Project	IEEE 802.16 Broadband Wireless Access Working Group < http://ieee802.org/16 >	
Title	Hierarchical MAP Structure	
Date Submitted	2004-11-15	
Source(s)	Hang Zhang, Mo-Han Fong, Peiyong Zhu, Wen Tong Nortel Networks	mhfong@nortelnetworks.com Voice: +1-613-765-8983 Fax: +1-613-765-6717
Re:	IEEE P802.16e/D5-2004	
Abstract	This contribution proposes to enhance the DL/UL MAPs to improve power efficiency for MSS in Sleep mode and Idle mode, and also to reduce overhead. This is a revised contribution. Changes are highlighted in blue.	
Purpose	Review and Adopt the suggested changes into P802.16e/D5	
Notice	This document has been prepared to assist IEEE 802.16. It is offered as a basis for discussion and is not binding on the contributing individual(s) or organization(s). The material in this document is subject to change in form and content after further study. The contributor(s) reserve(s) the right to add, amend or withdraw material contained herein.

Figure 1. Hierarchical MAP structure

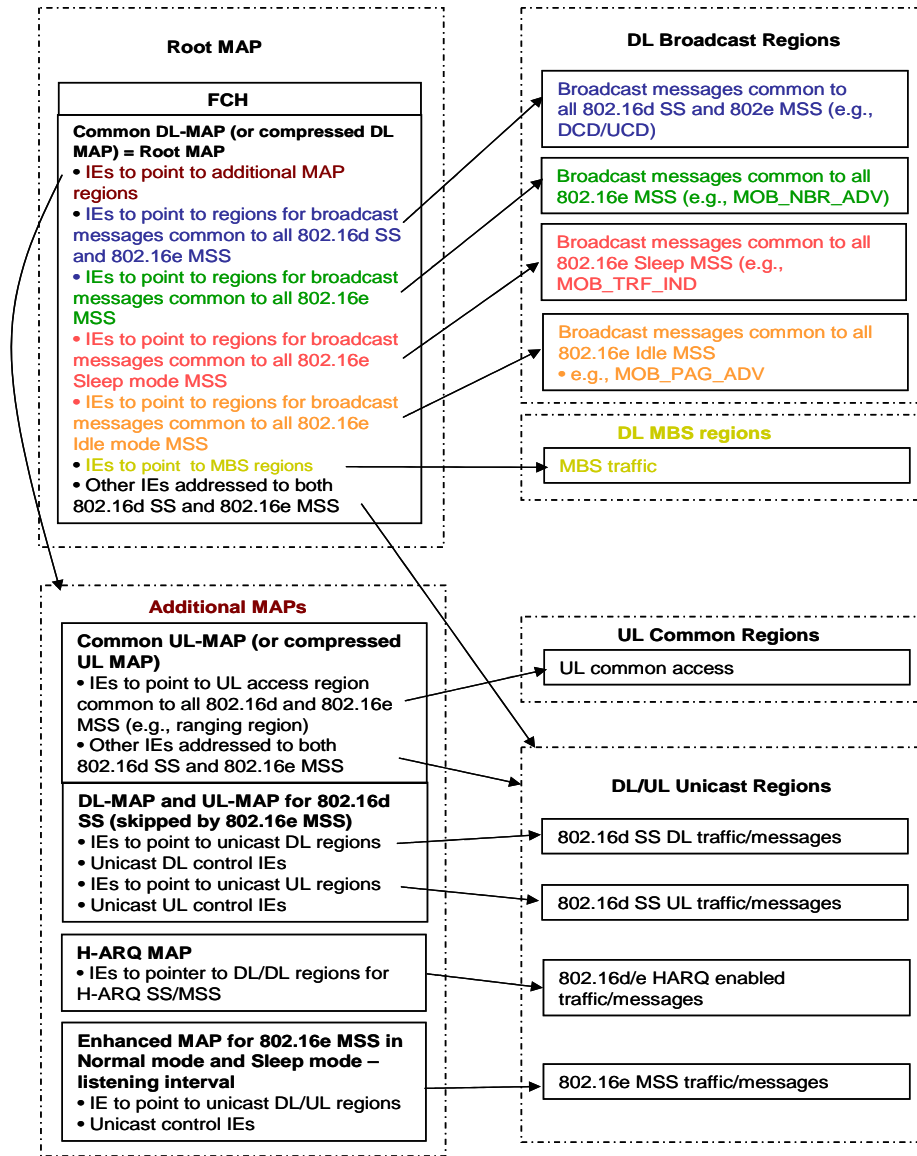
We propose a hierarchical MAP structure as shown in Figure 1. We use the first DL-MAP following the FCH as the Root MAP. Since this Root MAP is processed by all MSSs who intend to listen to DL traffic or messages including SS, MSS in Normal mode, MSS in Sleep mode – listening window, and MSS in Idle mode – Paging interval, this Root MAP contains IEs that points to additional DL and UL MAPs, where each of these additional MAPs only needs to be processed by a specific group of MSS, e.g. 802.16d SS, or 802.16e MSS in Normal mode, or 802.16e MSS in Sleep mode – listening window, or 802.16e in Idle mode – paging interval.

One example of how the MAPs can be partitioned is illustrated below and in Figure 1 (note that the regions shown in the figure are logical region rather than actual physical subchannel and OFDMA symbol space). In this example, the Root MAP includes the following:
